CITY OF
TUCSON

SUBJECT: Clarification of TMC Strategic Capitol Plan Improvements as Related to the Tucson Medical Center Planned Area Development

TMC Development Plan
SGA Project No. 1023.027

TMC DEVELOPMENT PLAN
EXHIBIT 'A'
NORTH

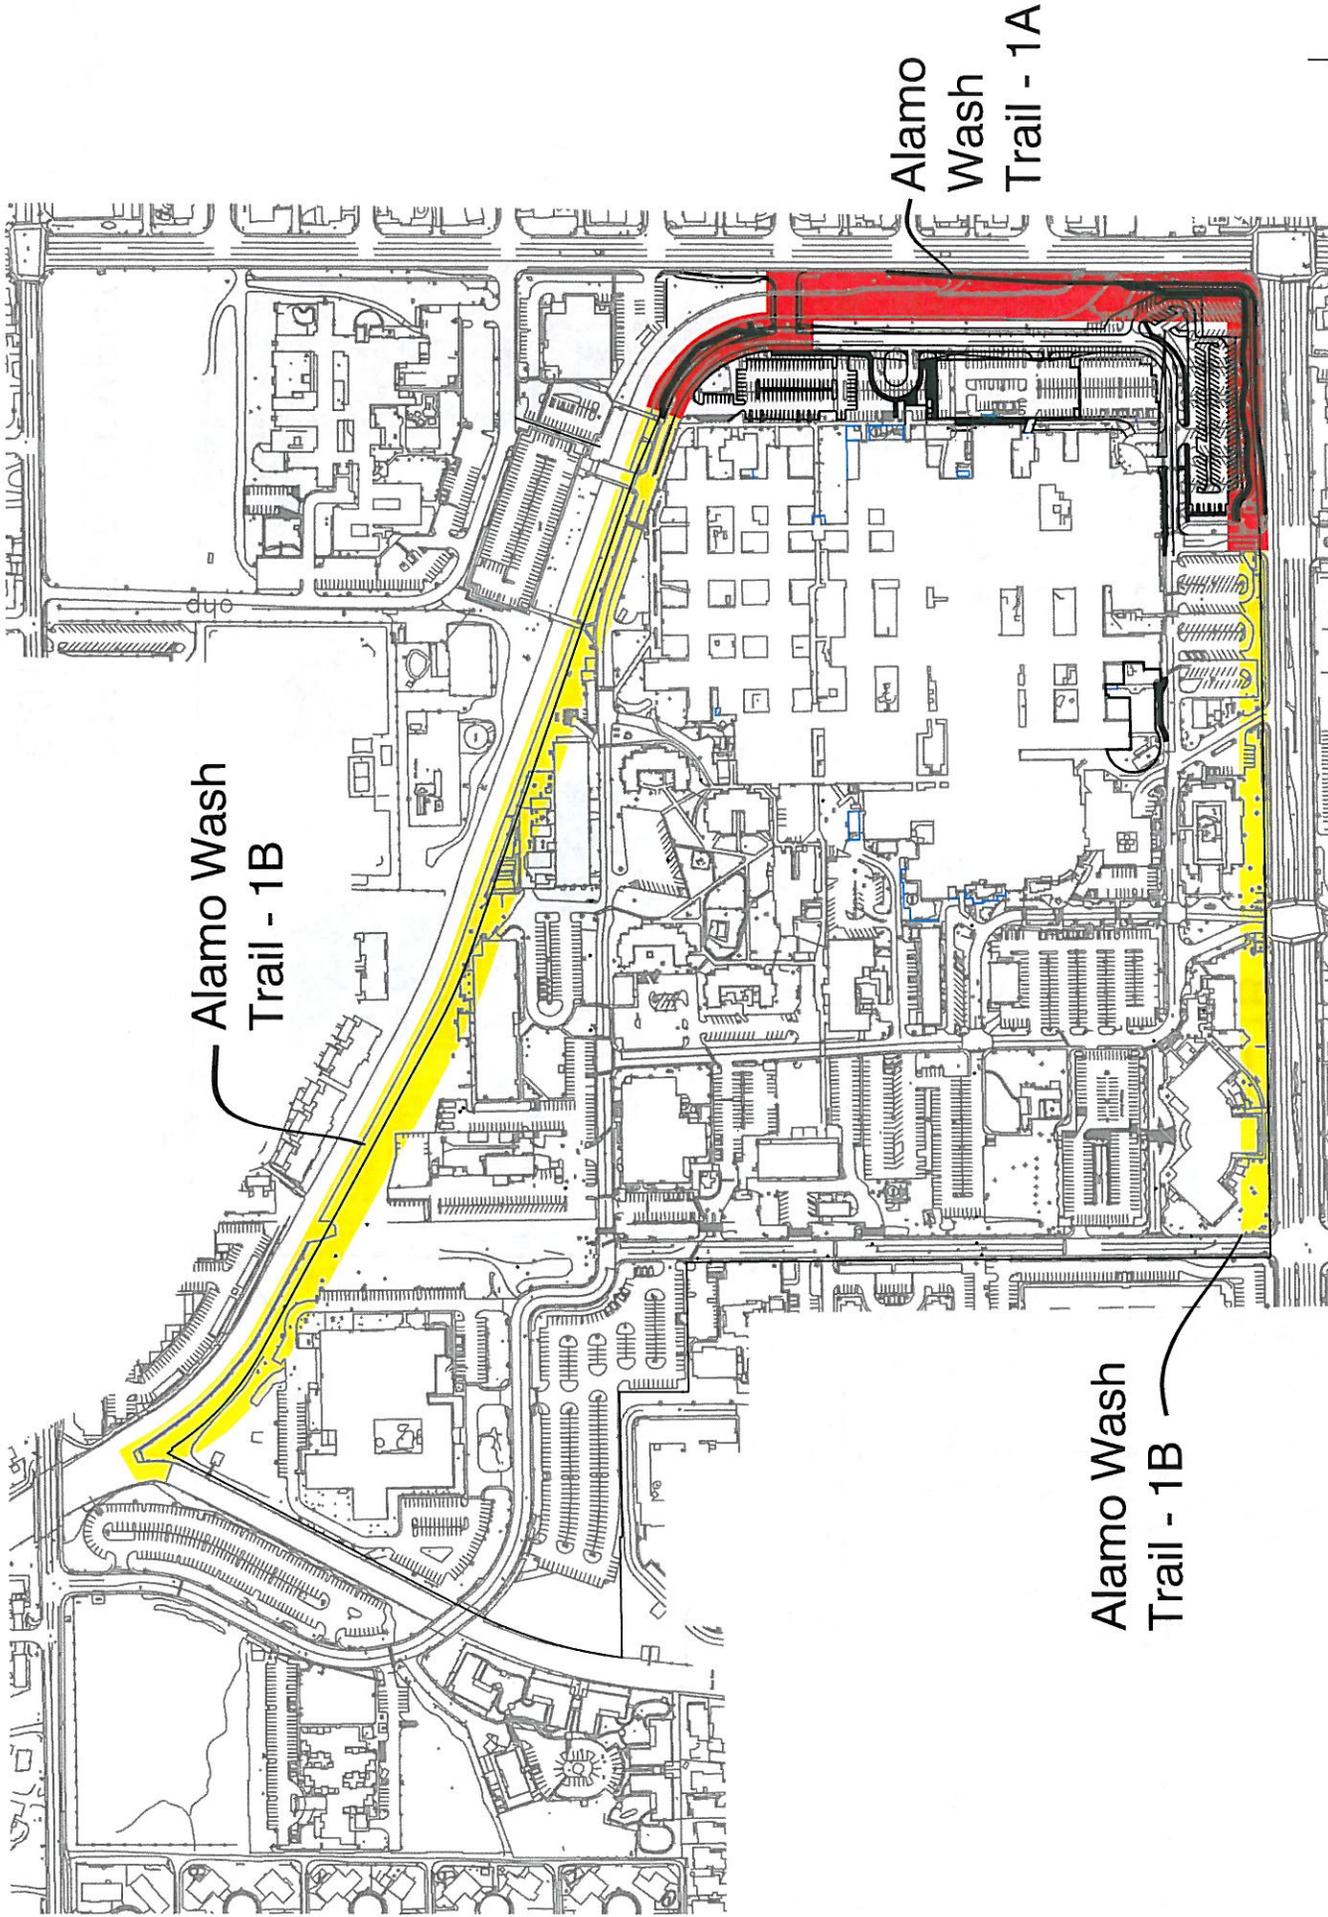
The PAD District outlines and provides for multiple phases of development to occur over a period of time. The current capital improvement project is slated to be completed over the next five years, by 2013. The PAD District document defines Phase 1 and Phase 2 as illustrated in Figure 27, Phase Areas, on page 70. In that light, TMC proposes the following phases:

Phase 1A – start construction in 2009

TMC and the design team would like clarification that this phasing meets the intent of the phasing described in the PAD District documents.

The applicant's request to alter or change the phasing, i.e. Phase 1A and Phase 1B is consistent with the PAD. However, whether called Phase 1 or Phase 1A, the first phase of TMC's capital improvement program must include improvements and construction for the entirety of the Alamo Wash Trail from the Grant/Craycroft intersection to Glenn Street; and the initiation of the procedures to place the Arizona, Patio, and Erickson buildings and Water Tower on the NRHP, initial preservation activities for the three buildings, and construction of the Founders Park.

TMC DEVELOPMENT PLAN
EXHIBIT 'B'

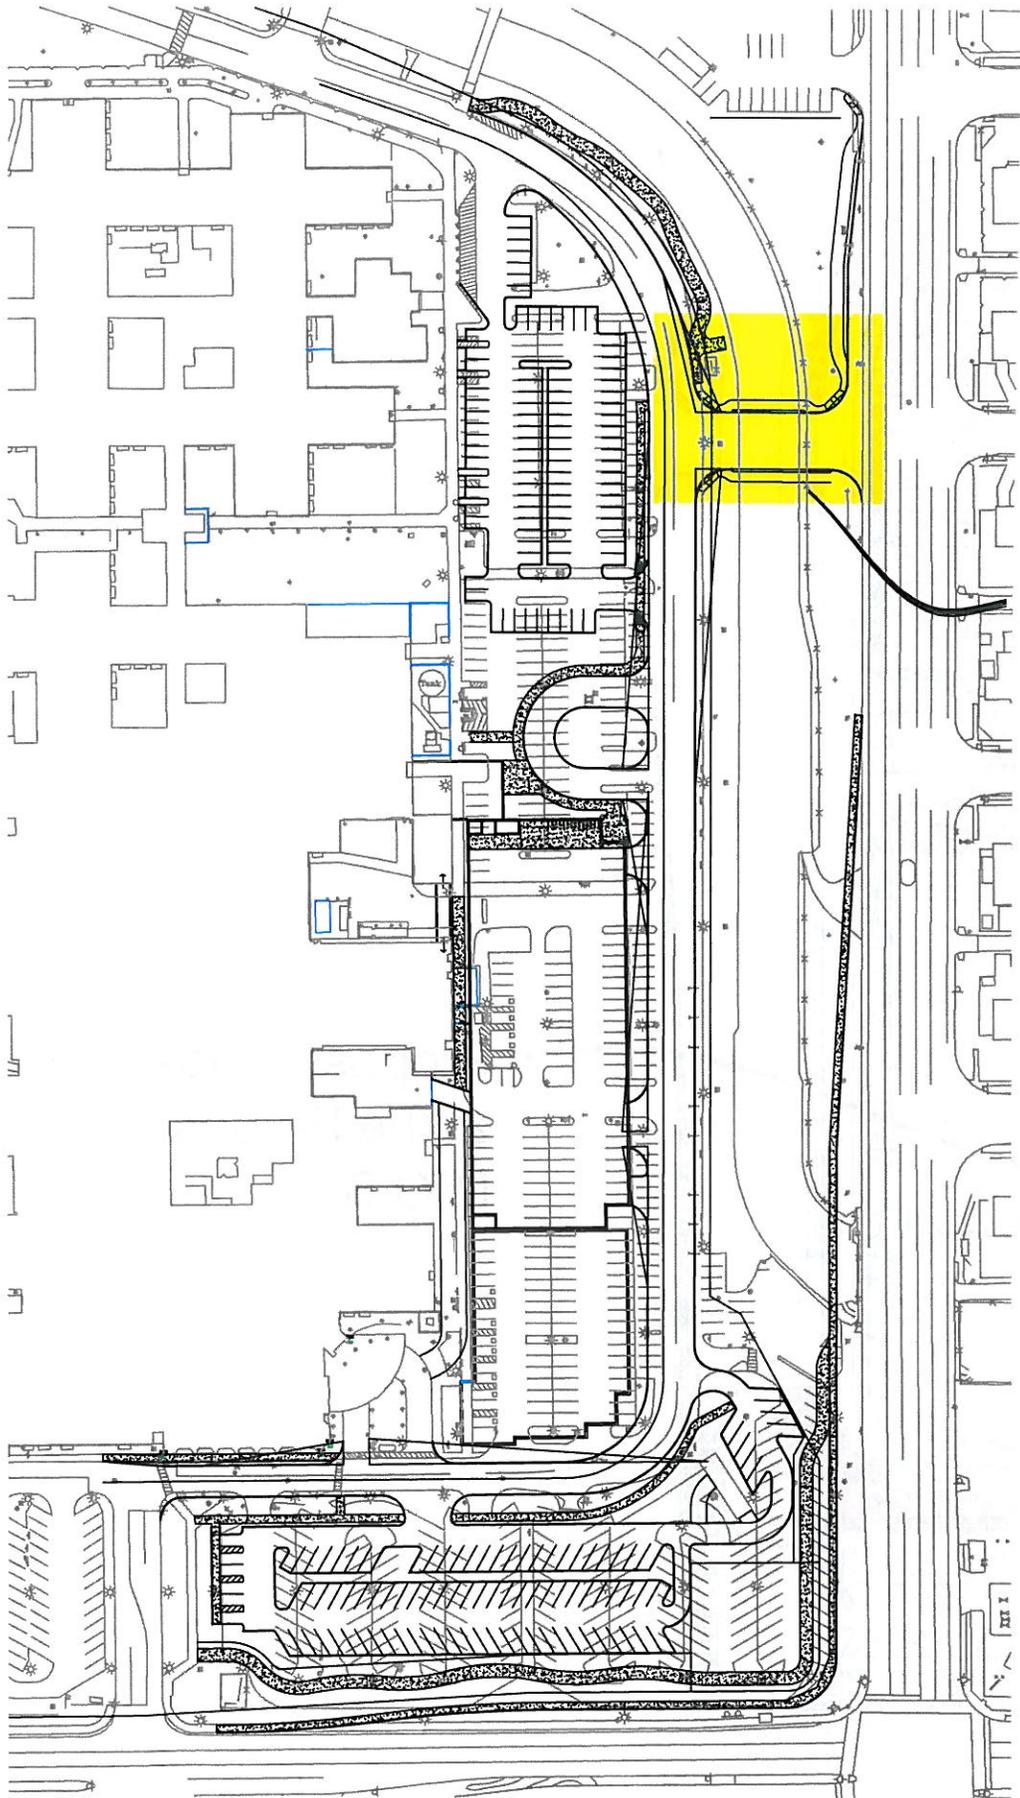
The PAD district indicates that the Alamo Wash Trail from the Grant/Craycroft intersection to Glenn Street , including the new pedestrian/trail bridge, needs to be constructed in Phase 1 in conjunction with the power plant improvements associated with the new hospital construction. The revised Phase 1A, 1B and 2A does not require the central plant expansion for any of the proposed new construction. TMC is requesting that the construction of the Alamo Wash Trail be constructed in phases to allow the maximum budget be used for specific patient care facilities. Phase 1B would complete Alamo Wash trail and landscaping from the existing Northeast Parking Garage to Glenn Street, including the pedestrian bridge over the Arcadia Wash at a point in time after 2013.

Please refer to the attached exhibit 'B' for a site plan that identifies the Alamo Wash Trail.

TMC and the design team would like approval of this phasing for the construction of the Alamo Wash Trail.

Craycroft Entry
Bridge

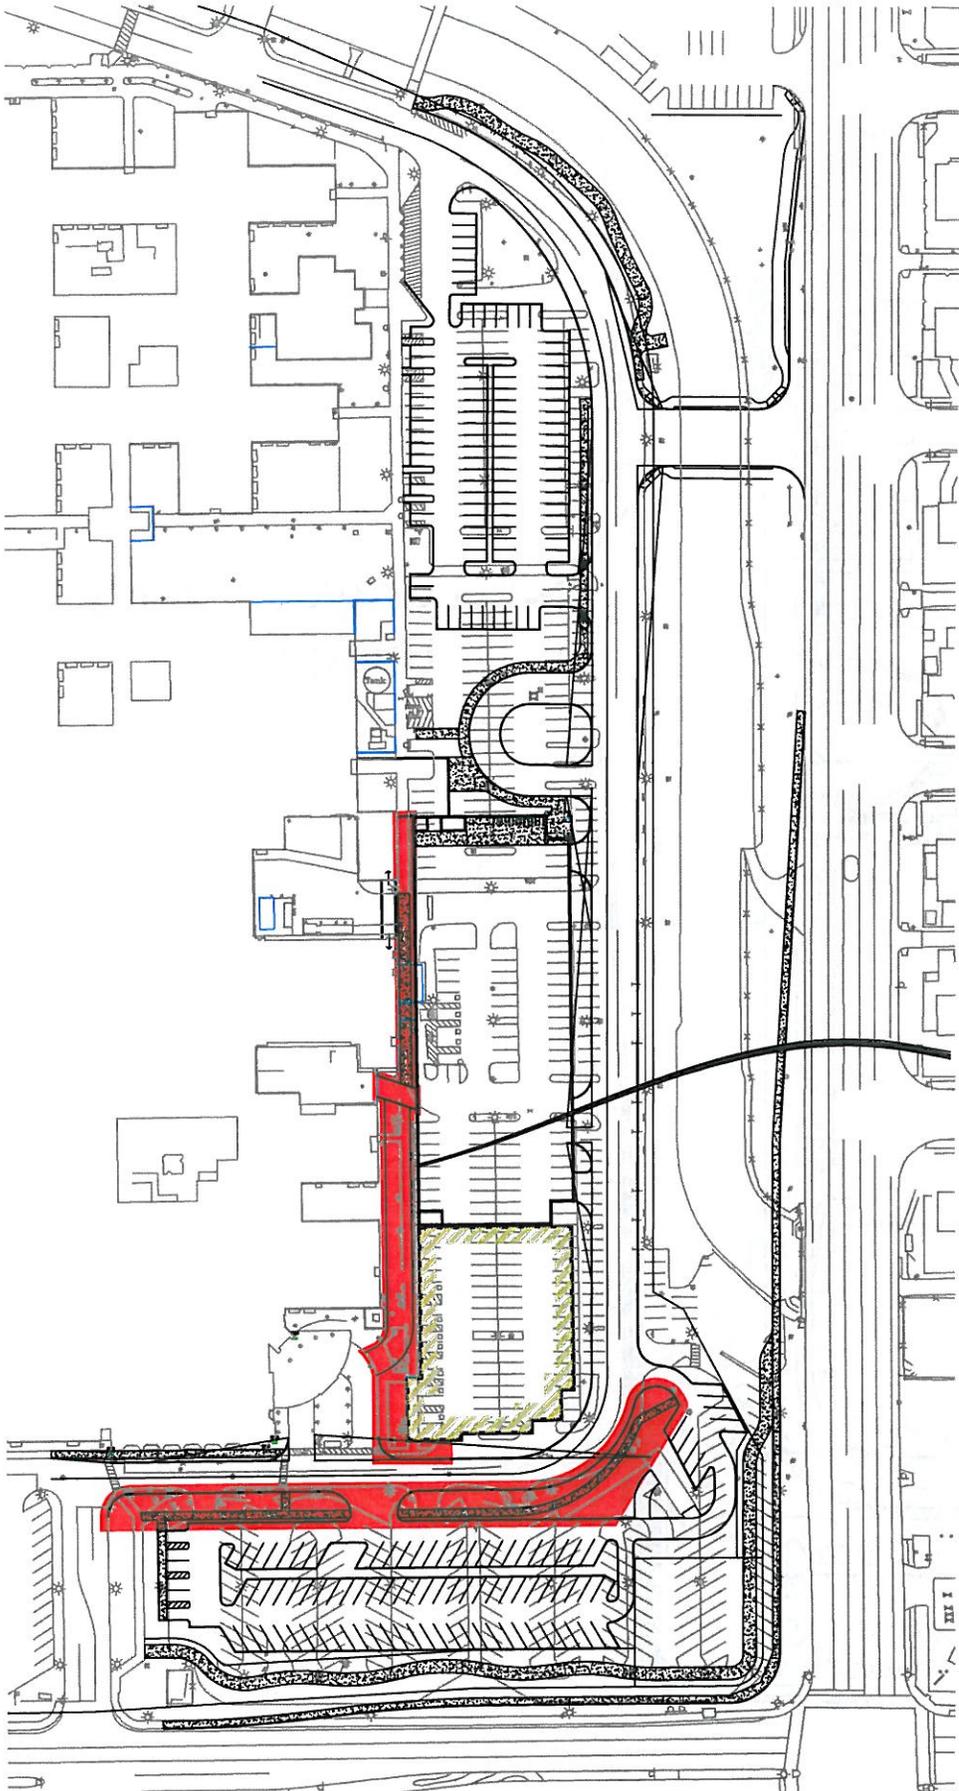
The PAD District street section Figure 18A, on page 41, will be revised to only a three lane bridge with pedestrian sidewalks but no median. There will not be a North/South pedestrian crosswalk on the West end of the new vehicular bridge but will have a North/South pedestrian crosswalk on East end parallel to Craycroft Road.

Please refer to the attached exhibit 'C' for a site plan that identifies the Craycroft Bridge and pedestrian bridge.

TMC and the design team would like clarification that this revision to the Craycroft Entry Bridge over the Alamo Wash meets the intent described in the PAD District documents.

- Craycroft Entry Bridge – the revision to only a three lane bridge with pedestrian sidewalks on both sides, and no median meets the intent of the TMC PAD document which requires vehicular, pedestrian and bicycle access across the entry bridge. A new cross section will need to be submitted, reviewed, and approved by Jose Ortiz – City of Tucson Traffic.

TMC DEVELOPMENT PLAN
EXHIBIT 'D'

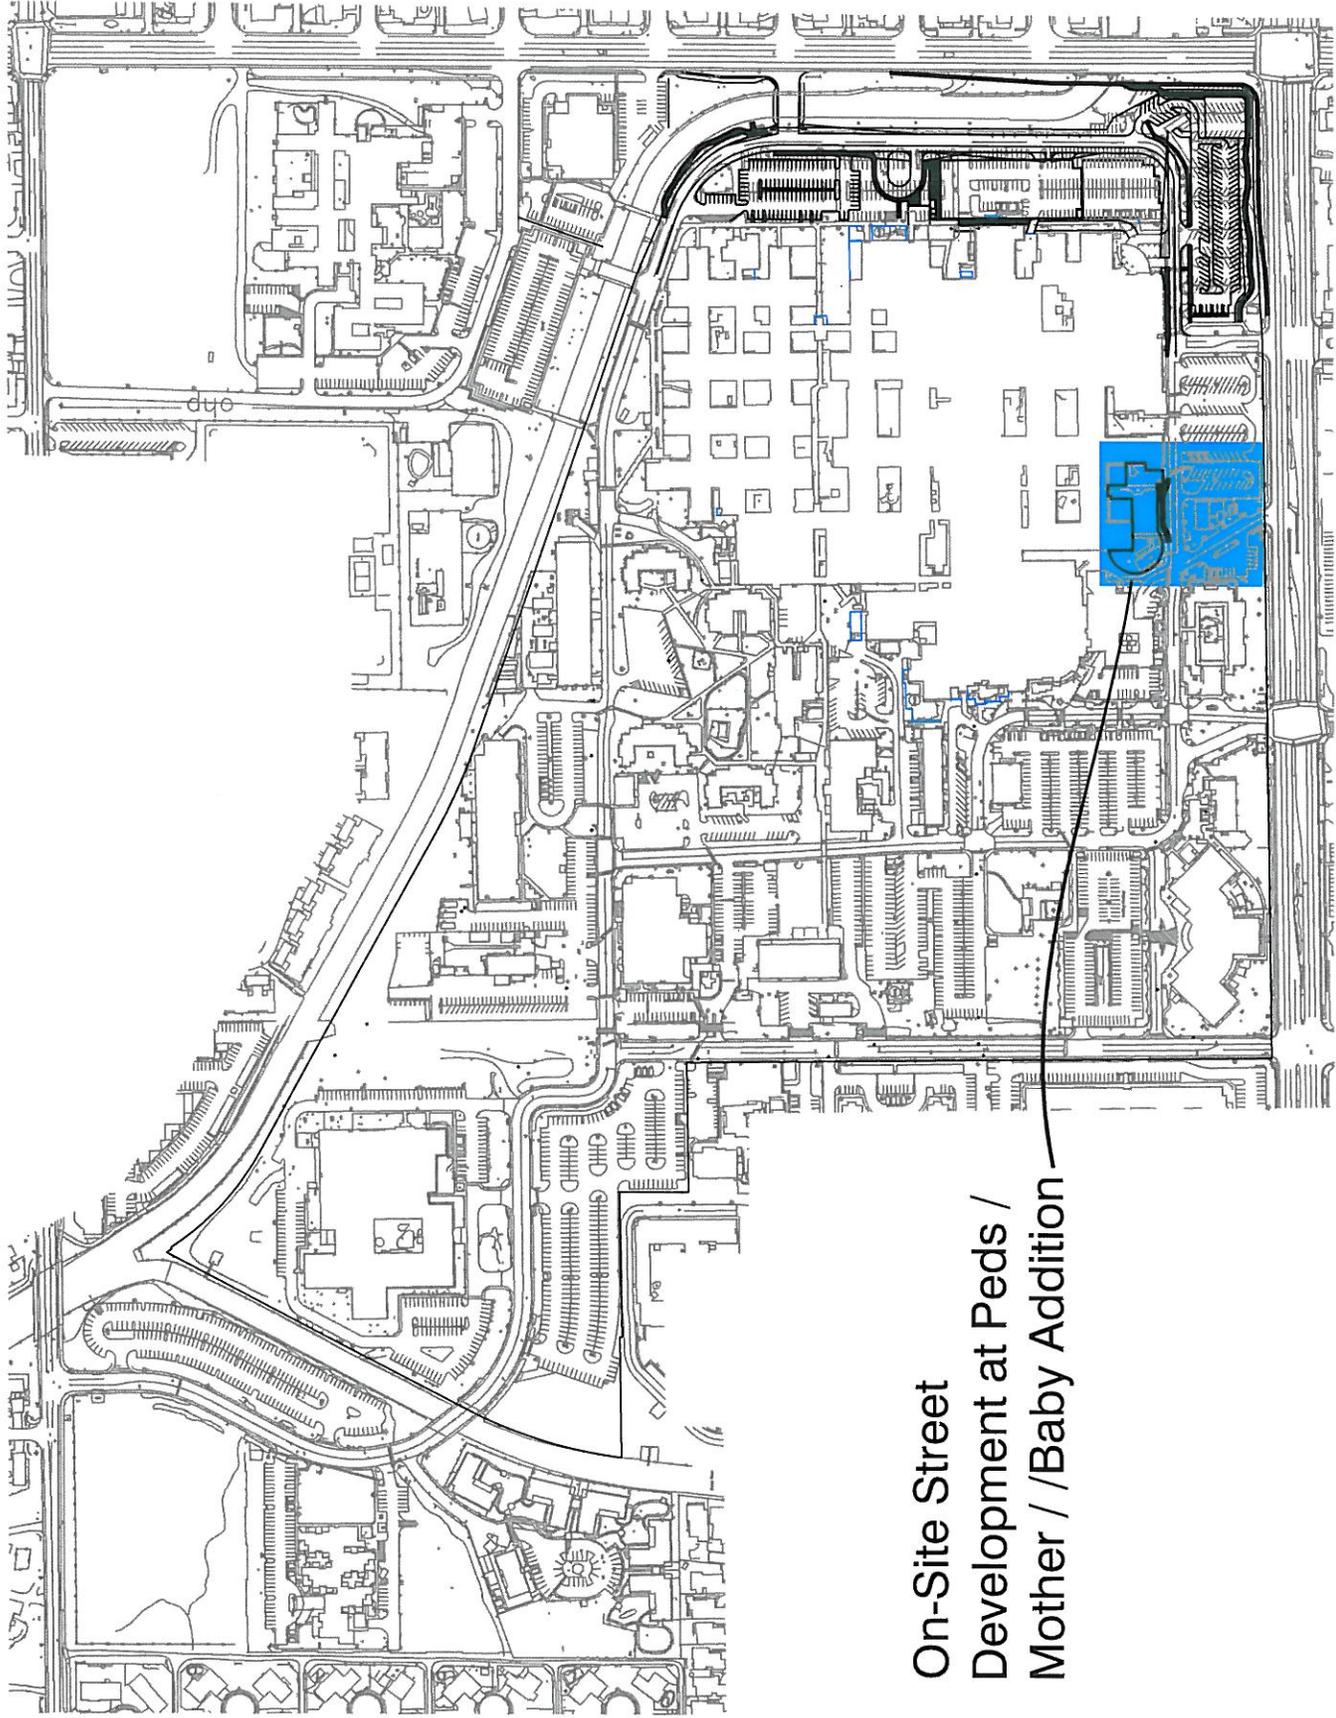
The main entrance to the MOB is intended to be at the Southwest corner, adjacent to the existing Women's Center entrance. Additional entries will be provided at each level of the parking structure on the Northwest corner. With these entries, it is anticipated that there will be minimal if no pedestrian traffic on the East and South sides of the MOB, thus the need for a pedestrian sidewalk does not exist. Pedestrian access will be available to travel North and South between the existing structure and the MOB/parking structure. A pedestrian crosswalk will also be provided at the Southwest corner of the MOB to provide access from the new parking lot to the South. The PAD District suggests that sidewalks or pedestrian paths be provided on both sides of a street or roadway except if development is only on one side of the street or roadway, the sidewalk or pedestrian path may be provided only on the side of the development. COT staff has also indicated that the Development Standards require sidewalks adjacent to a building, but that the presented concept may warrant an exception.

Please refer to the attached exhibit 'D' for a site plan that identifies the Pedestrian Sidewalks within the PAD District, specifically at the proposed MOB.

TMC and the design team would like clarification that this interpretation of the PAD District requirements and the Development Standards is an approved option for Pedestrian Sidewalks within the PAD District, specifically at the proposed MOB.

- Pedestrian Sidewalks within the PAD District, specifically at the proposed Medical Office Building – the request to eliminate pedestrian sidewalks along the eastern and southern edges of the MOB can be supported (but a DSMR would be needed) as the main entrance to the MOB is intended to be at the southwest corner, and an additional entry at the northwest corner of the building, with no anticipated pedestrian traffic on the east and south sides of the MOB. There are to be no access points along the east and west sides of the MOB. Pedestrian access to travel north/south between the existing structure and the MOB/parking structure should be clear and easily available.
